## HISTORIC AND DESIGN REVIEW COMMISSION

March 2, 2022

**HDRC CASE NO:** 2022-092  
**ADDRESS:** 115 QUEENS CRESCENT  
**LEGAL DESCRIPTION:** NCB 3087 BLK 3 LOT S IRR 99.22 FT OF 17 0.235 AC  
**ZONING:** R-4, H  
**CITY COUNCIL DIST.:** 1  
**DISTRICT:** Monte Vista Historic District  
**APPLICANT:** Angela Blake/BLAKE ANGELA LUTHI & TIMOTHY LEE  
**OWNER:** Angela Blake/BLAKE ANGELA LUTHI & TIMOTHY LEE  
**TYPE OF WORK:** window replacement, siding replacement  
**APPLICATION RECEIVED:** January 18, 2022  
**60-DAY REVIEW:** Not applicable due to City Council Emergency Orders  
**CASE MANAGER:** Hannah Leighner  
**REQUEST:**

1. Replace existing metal casement windows with wood windows.
2. Replace the existing tiled siding with new lapped siding

# Building Sketch

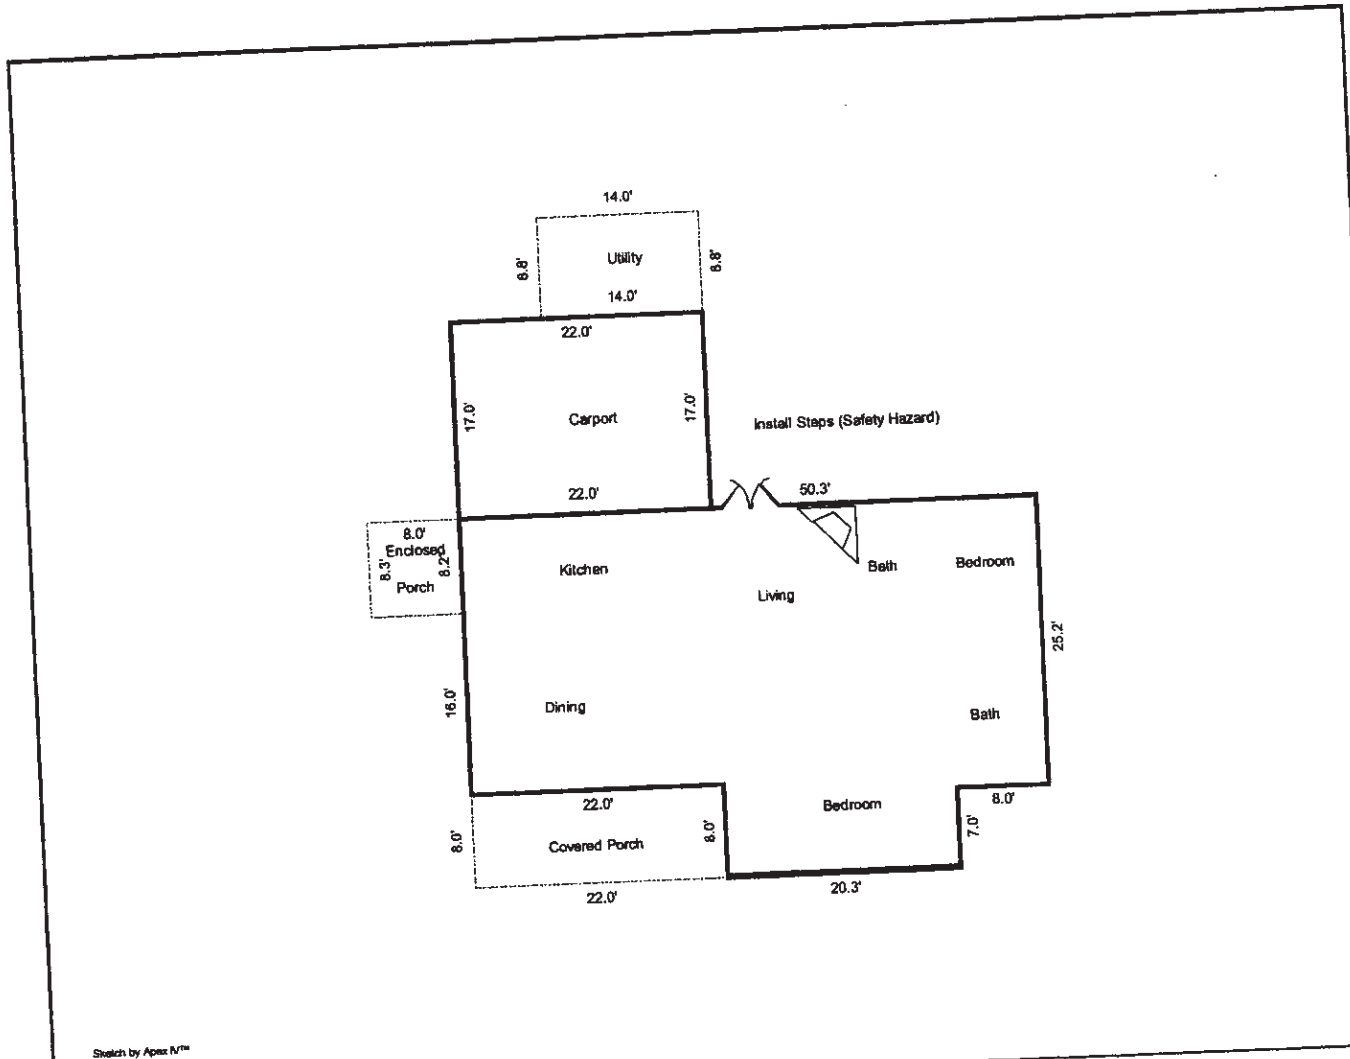
X's : new siding will  
replace current  
siding from 1948.

front main bedroom  
window replacement  
metal to wood

side main  
bedroom  
window  
replacement  
vinyl to wood

right side of  
front door  
window  
metal to  
wood

left side of  
front door  
window  
metal  
to wood

front porch  
window replacement  
metal to wood

window replacement  
metal to wood  
Dining room  
side

Back bedroom  
side  
window  
replacement  
vinyl to  
wood.

new  
siding  
ends

new  
siding  
already  
installed
